Design Review Board

November 14, 2018

Application #092190. Project Manager Gray introduced the applicants and summarized the staff report for the #1 Food Store Site Improvements with a PowerPoint presentation:

The property owners have submitted an application (*attachment 1*) to the Design Review Board for property improvement to the existing fueling station site at the # 1 Food Store, located at 755 State Route 89A, parcel #400-05-010H. The property is zoned (C) Commercial.

Fig. 5 Proposed Circulation

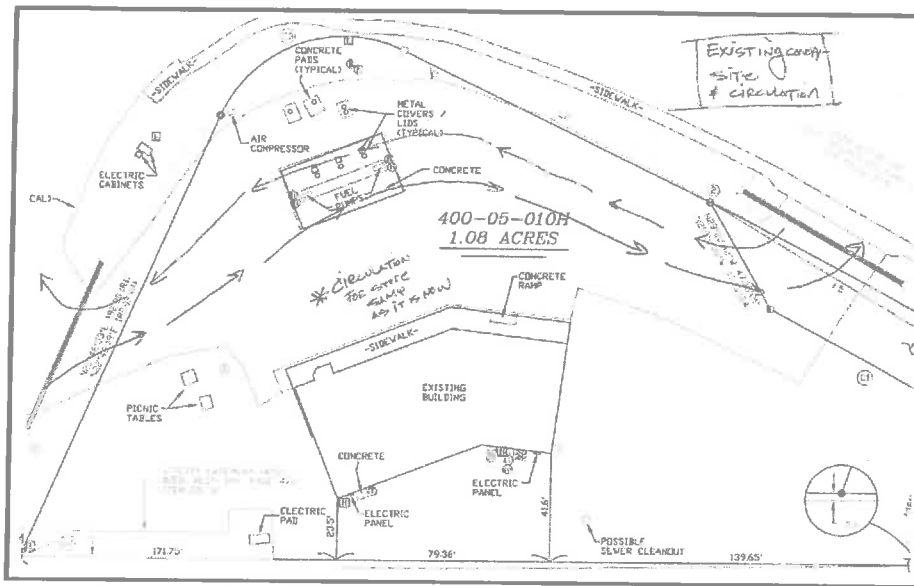
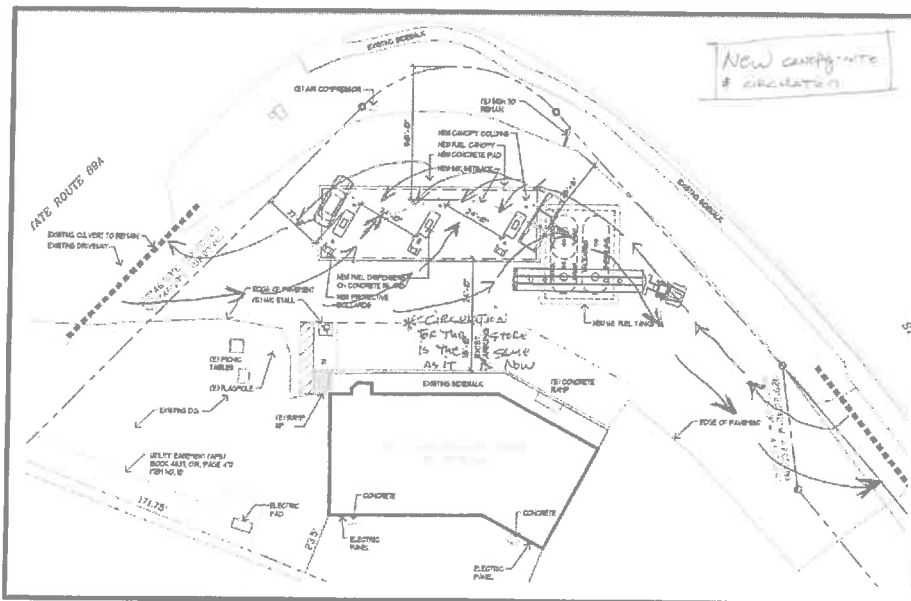
Traffic flow: The pump stations will be in a similar location, but angled, requiring traffic to turn slightly, altering the existing traffic pattern (see *Fig. 4 & 5*).

1. **Clarkdale Police Department:** Expressed a concern about having seen heavy trucks at the location and anticipates problems with the tightened turning radius posed by the new traffic flow plan. **Staff note:** Large delivery trucks have been observed accessing the site, but not for fueling purposes. Applicant states the existing circulation pattern of delivery trucks will not be impacted by the proposed changes.

- a. **Applicant response:** "The current #1 Food Store is designed as a convenience store with fuel for automobiles. This location is not designed for fueling of large diesel (semi) trucks (typically found) at a truck stop location on a major highway like I-10 to California and as depicted in the attachment sent. The re-design maintains this concept. Additionally, the new design with the relocation of the fuel tanks provides for a much more logical tank location with better and easier access for the fuel truck to get in and out of the site without having to maneuver around the canopy, cars fueling & the pumps (like the current configuration does). The site plan depicts a fuel truck that is able to pull straight in and leave the site without

having to go around the canopy, thus making the site flow much better. Lastly, the flow volume of the fuel dispensers themselves will not satisfy what is required for a semi-truck and Semi-Truck drivers understand this and know it is not a location that meets their fueling requirements or needs."

Fig. 6 Canopy Elevation & sign area

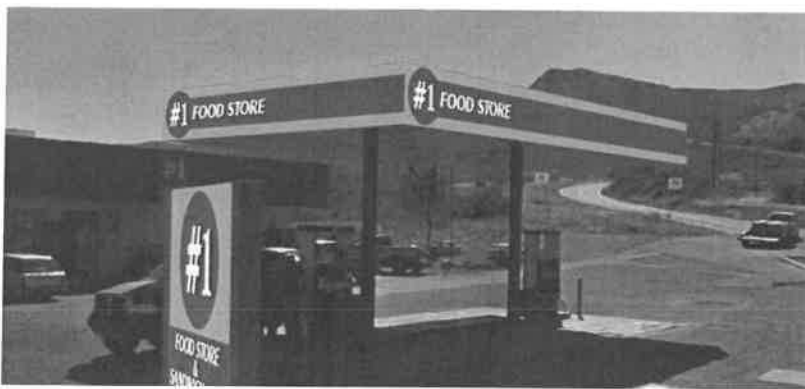
Canopy signs will be placed on all four fascia surfaces of the new structure. The canopy signs will be simple, vinyl lamination and will bear the #1 Food Store logo in colors specified in **Fig. 6**. Only the area of the decal covered by the characters “#1 Food Store” is considered sign area. Based on the images in Fig. 6, each “sign” is approximately 3’8” x 12’ or 44 square feet. The total signage area as proposed is approximately (44 sf x 4) 176 square feet. The signage on the canopy will not be reflective or illuminated.

Fig. 7 Main Building Color Theme

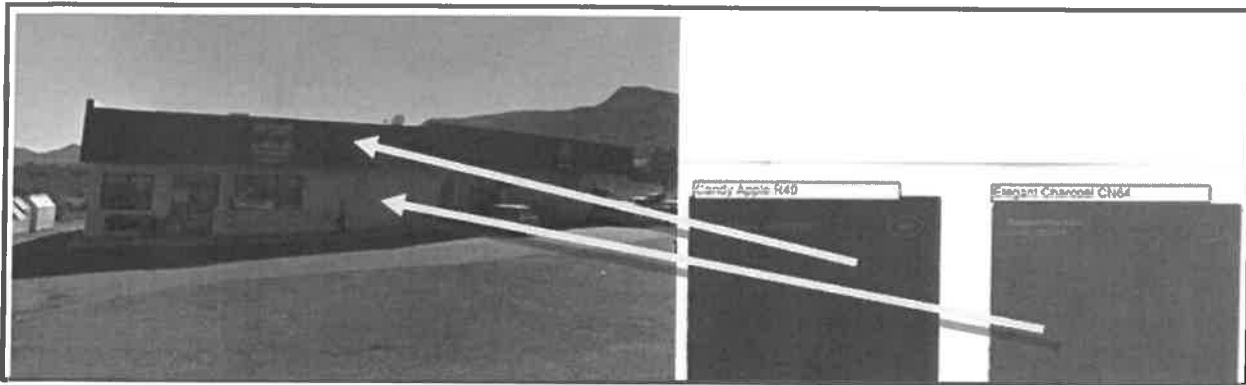
The applicant states the existing blue fascia and trim will be painted Candy Apple (R40), and the existing cream colored, exterior walls will be painted Glidden Elegant Charcoal (CN64) (*see Fig. 7*). This color scheme is consistent with the applicant's other location, the "QC Quick Country Store" at 9100 Western Drive in Cottonwood (*see Fig. 8*).

The application complies. Staff believes the new color scheme will refresh the appearance of the existing site.

Fig. 10 Improvements to existing sign

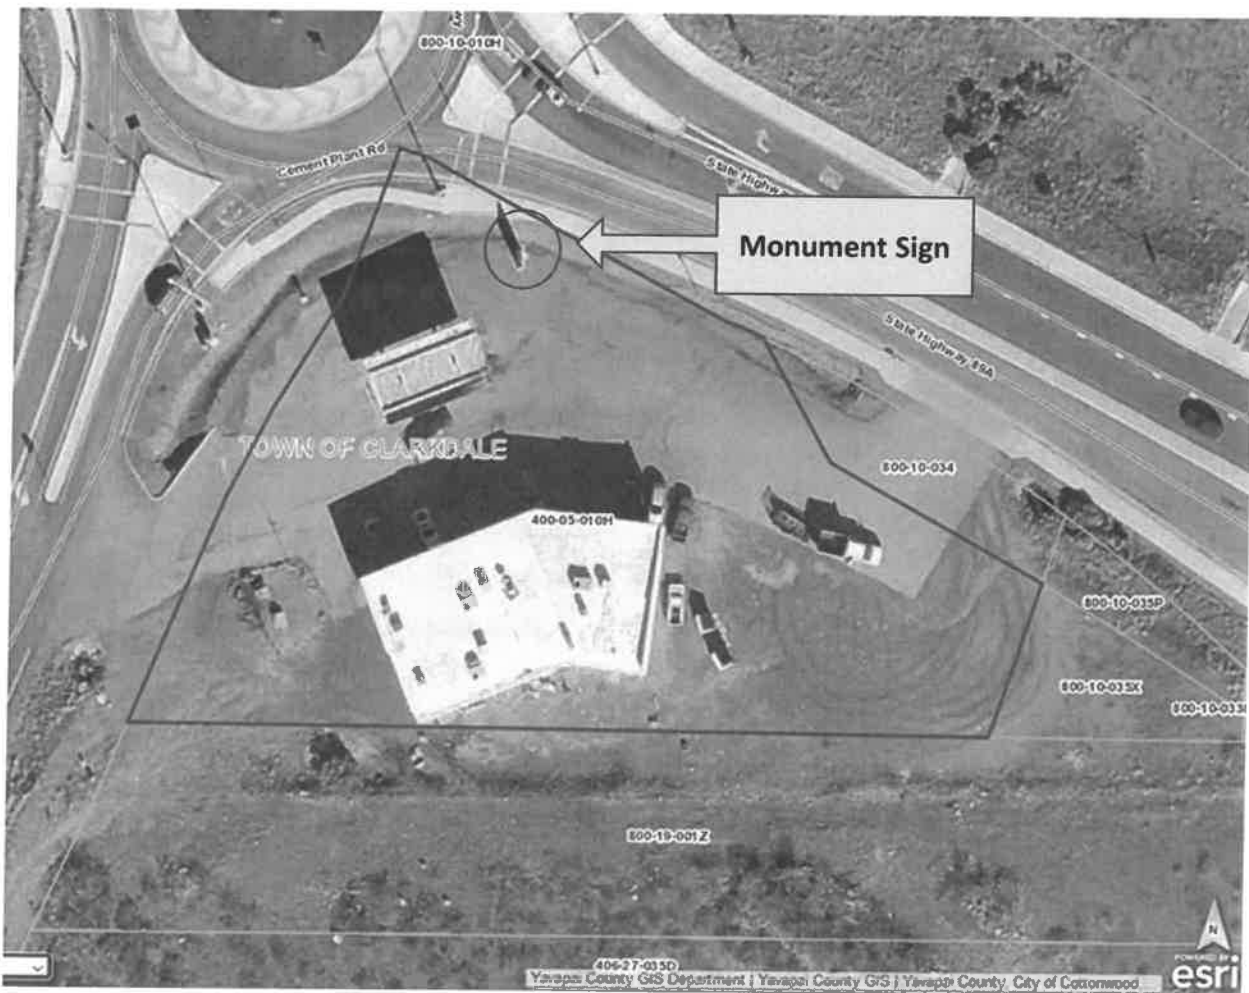
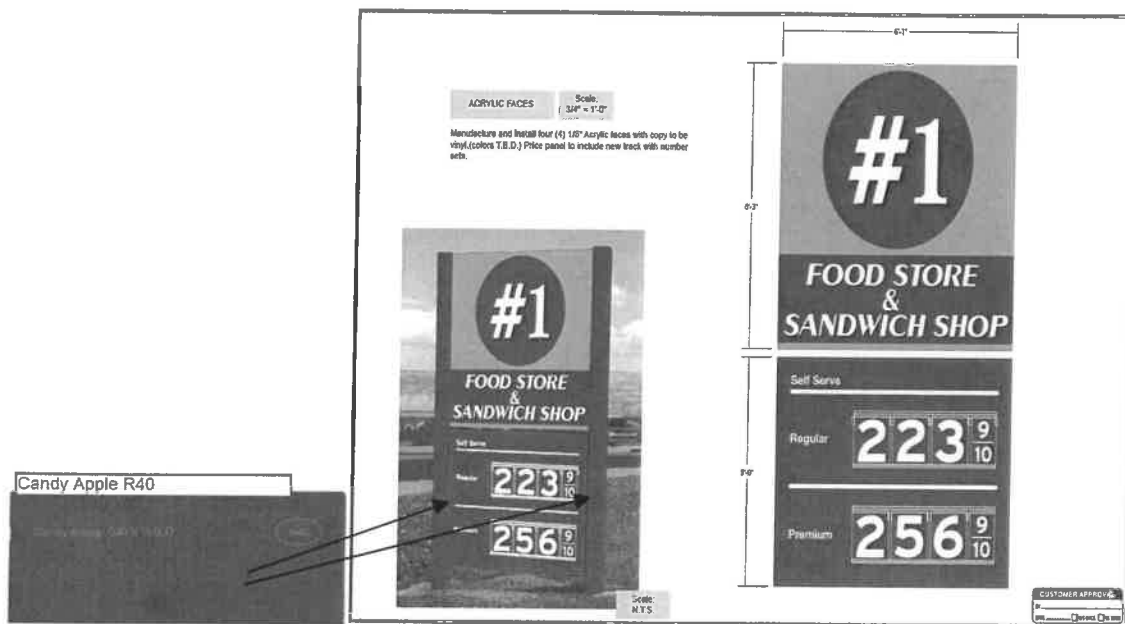
The applicant proposes to improve and refinish the existing badly weathered monument sign (*Fig. 9*) to match the proposed décor of the canopy. This is already an illuminated, non-reflective sign. The applicant proposes to paint the existing sign posts to R40 Red as specified in *Fig. 10*.

The existing sign is considered legal, non-conforming as it is only 9'11" from the back of sidewalk. It would need to be at least 12'4" from the back of the sidewalk to comply, (*see item 6 below*), but this situation was created by the SR 89A improvement project completed by ADOT.

The existing sign does not comply, as it stands 12'4" high, however, the sign existed prior to adoption of the current code and is determined to be legal, non-conforming.
